Docket Item #s 8 & 9
BAR CASE # 2009-0016 &
BAR CASE # 2009-0017

BAR Meeting
April 1, 2009

ISSUE: Addition and alterations and Waiver of HVAC Screening Requirement

LOCATION: 117 South Lee Street

Figure 12. Proposed floor plan with altered front stoop.

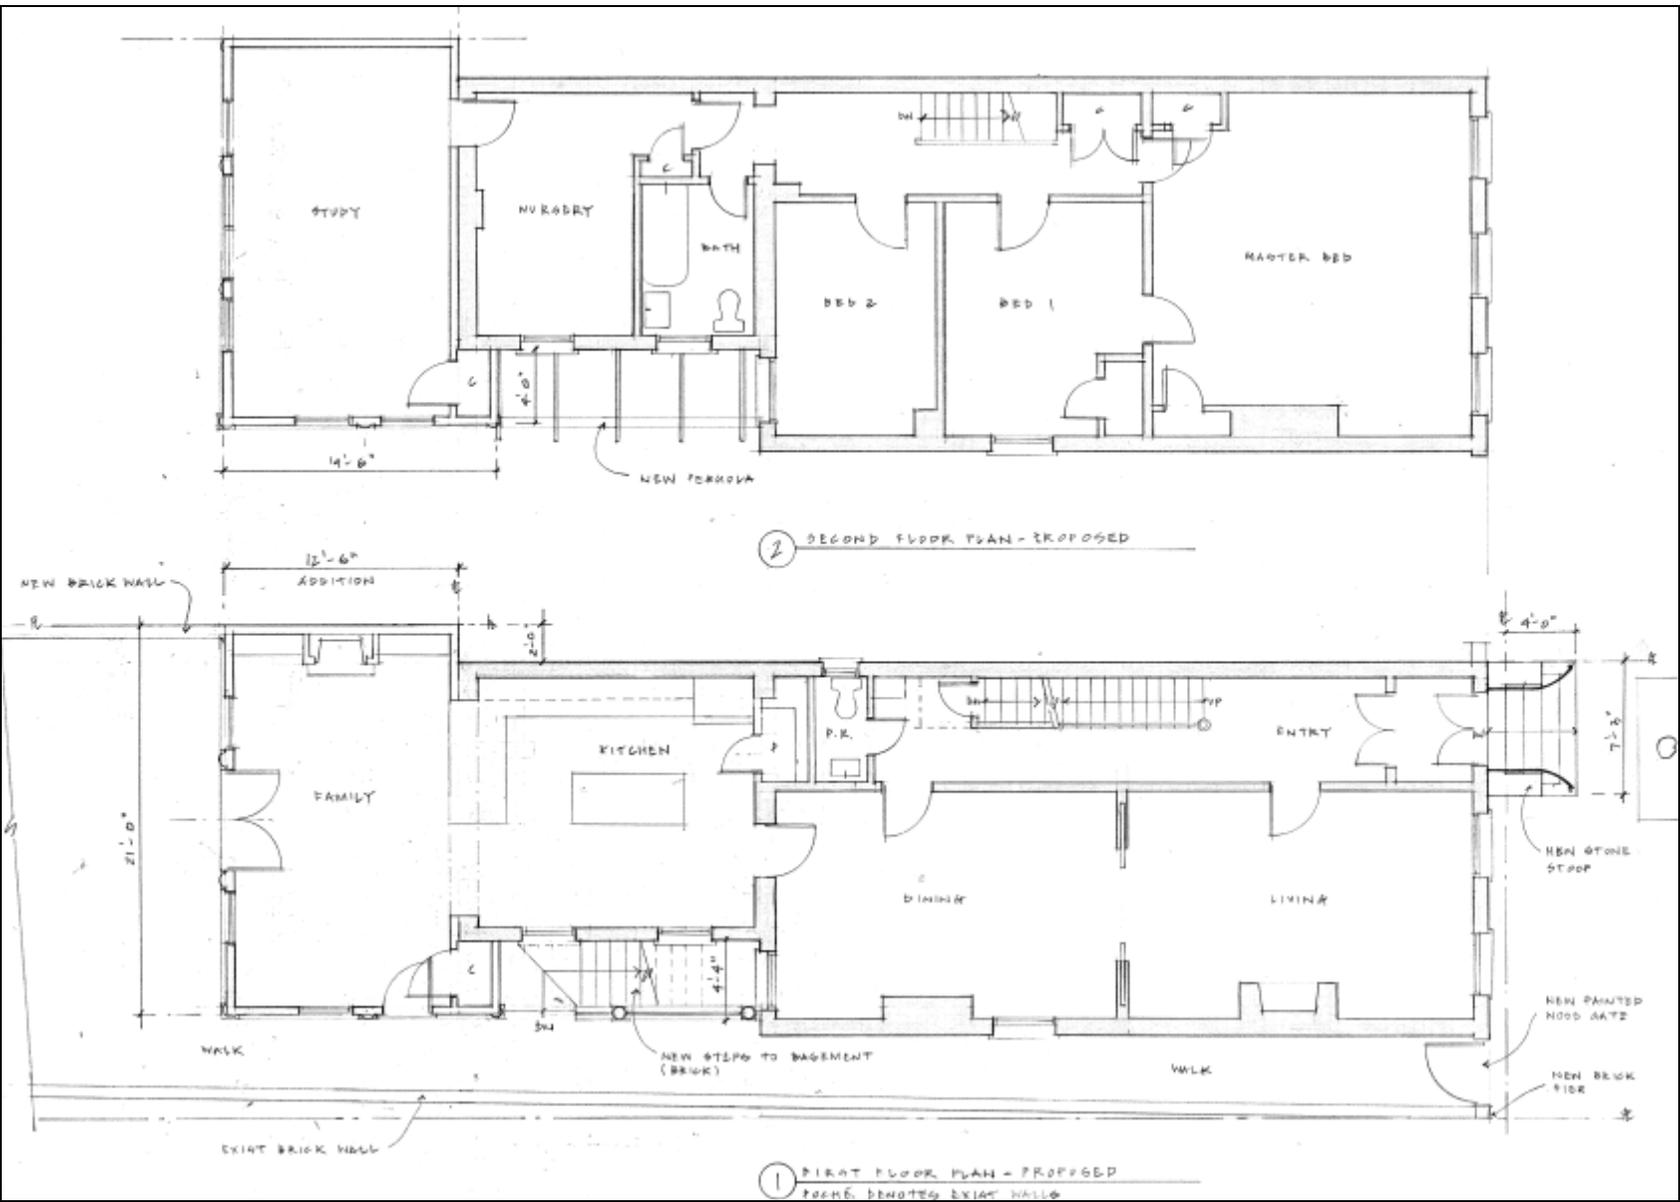
The applicant is proposing to remove the existing side-oriented front stoop. The proposed stoop and stairs will encroach 4 feet into the public right-of-way. The stoop will be limestone with an iron railing, curving outward at the bottom tread. New light fixtures are proposed on either side of the door and will be simple metal framed lanterns measuring 10.5 by 11.5 by 18.75 inches. The applicant proposes new ironwork at the basement windows.

The existing side-loading front stoop, made of brick and concrete, does not appear to be historic. The proposed limestone stoop is consistent with the *Design Guidelines* which state that “stoops, steps and railings should be made of materials which are sympathetic to the building materials generally found in the historic districts” and “should be appropriate and compatible with the historic architecture of the building.” Staff continues to find that the proposed limestone stoop is compatible.

Figure 13. Proposed alterations to rear yard area including garden walls, pergola and shed.

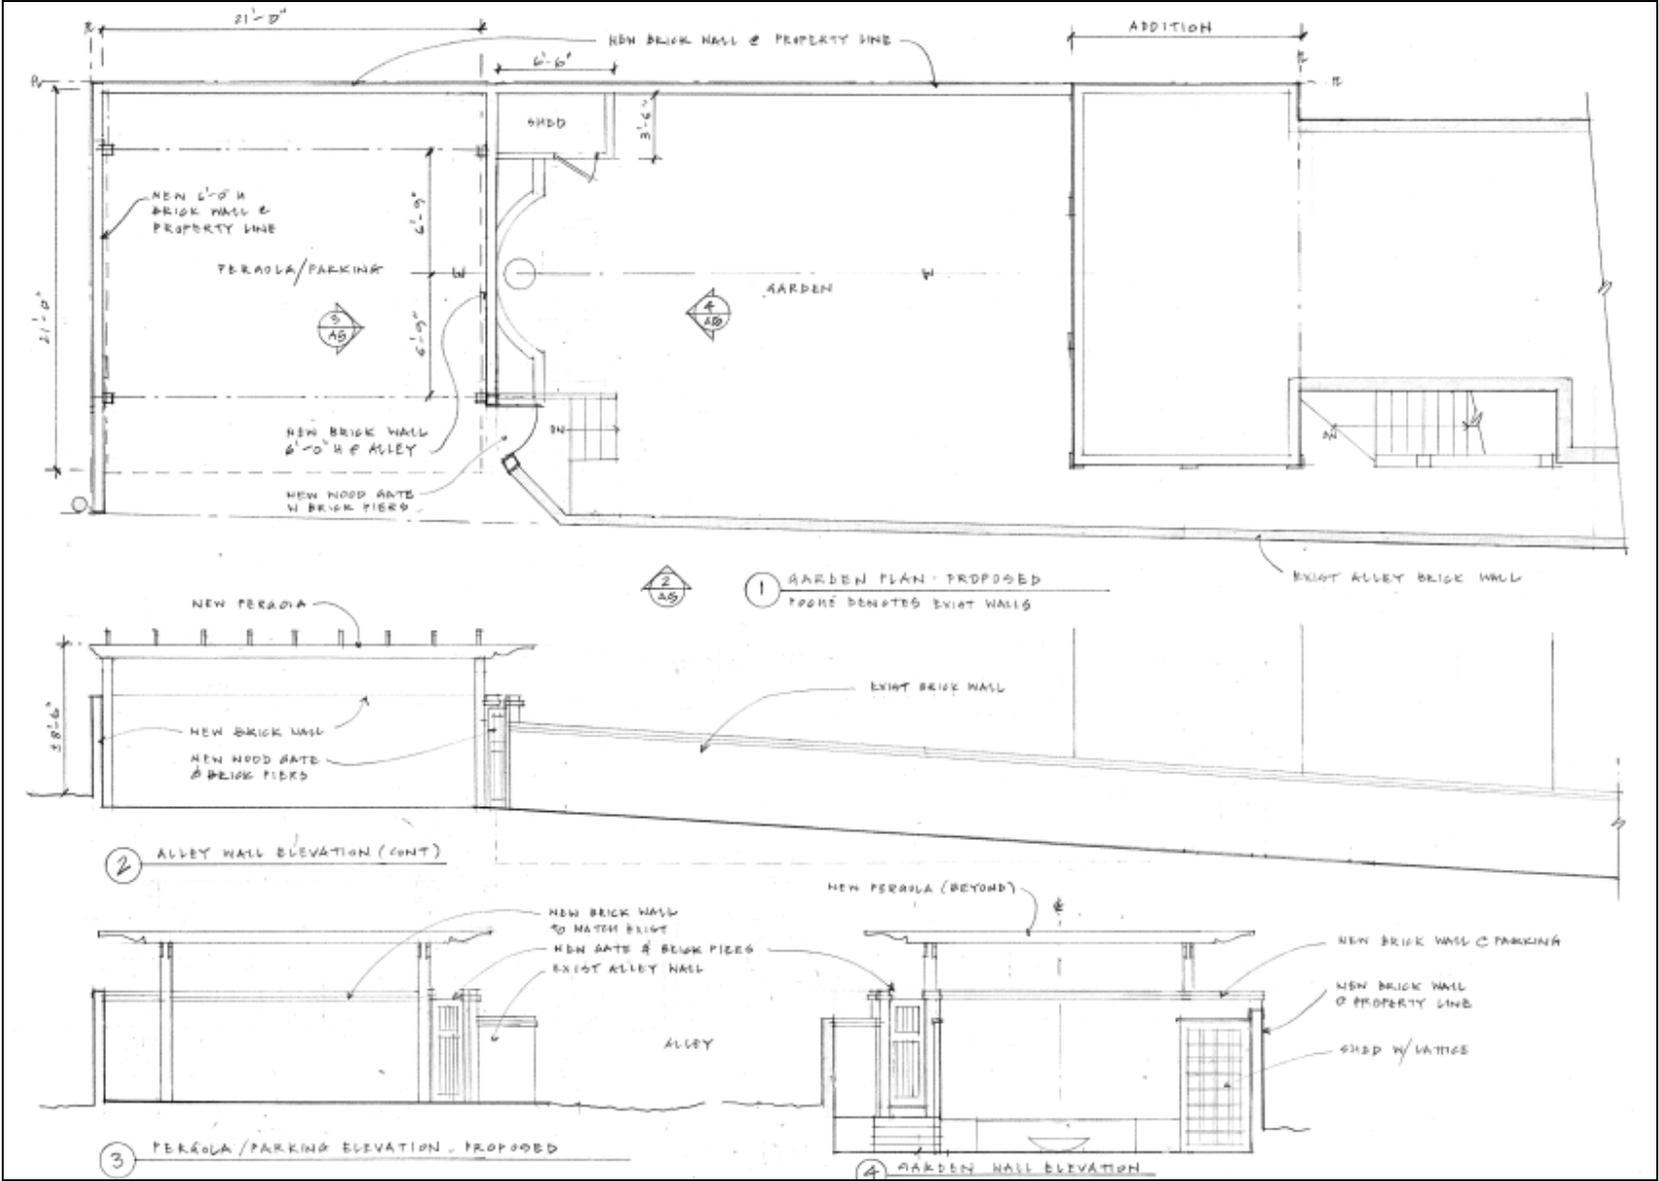
The applicant proposes several alterations to the historic brick garden wall. On the front (east) elevation, the applicant proposes to construct a new 6 foot brick pier at the corner and install a new painted wood gate. The applicant no longer proposes any demolition, encapsulation or alterations to the historic garden wall. Adjacent to the historic garden wall and parking area, the applicant proposes to construct two brick piers and a wood gate, providing access from the garden to the parking area. A new brick wall, 6 feet in height, is proposed to be constructed where a non-historic brick wall currently separates the garden from the parking area. A new brick wall, 6 feet in height, is proposed to be constructed at the rear (west) property line. A wood pergola at least 80% open and measuring 8.5 feet in height will be constructed over the parking area.

On the north property line the applicant is proposing to remove a dilapidated wood fence and construct a new brick wall measuring 6-6.5 feet in height in a stepped scheme.

The *Design Guidelines* pronounce that “an important visual feature of the historic districts are the fences, garden walls and gates that define property lines...[and] serve as a distinctive feature of the streetscape and individual yards.” Originally, the applicant proposed demolition and alterations to the historic garden wall on the alley (south) property line, which was of great concern to Staff. The applicant has since revised the application to leave the historic garden wall untouched. Staff finds that the construction of new brick piers, adjacent to the historic garden wall are appropriate and will ensure that the historic garden wall will be retained as both a useful and historic element. Staff finds that the new brick garden wall on the north and west property lines is acceptable as it has been revised to be no higher than 6-6.5 feet in height above grade at the property line and is stepped to accommodate grade changes without added height. This contrasts with the original submission which proposed a height of 8.5 feet on the north property line.

Staff finds the proposed pergola over the parking area to be appropriate in design, scale and materials. The proposed alterations to the garden area, including the shed, are appropriate. Due to the reduction in grade in the rear yard, the shed will be minimally visible. The proposed painted wood gates are appropriate.

2. That the applicant should reuse all historic brick on the altered garden wall located at the west (rear) property line.
3. *The applicant/developer shall call Alexandria Archaeology immediately (703-838-4399) if any buried structural remains (wall foundations, wells, privies, cisterns, etc.) or concentrations of artifacts are discovered during development. Work must cease in the area of the discovery until a City archaeologist comes to the site and records the finds.
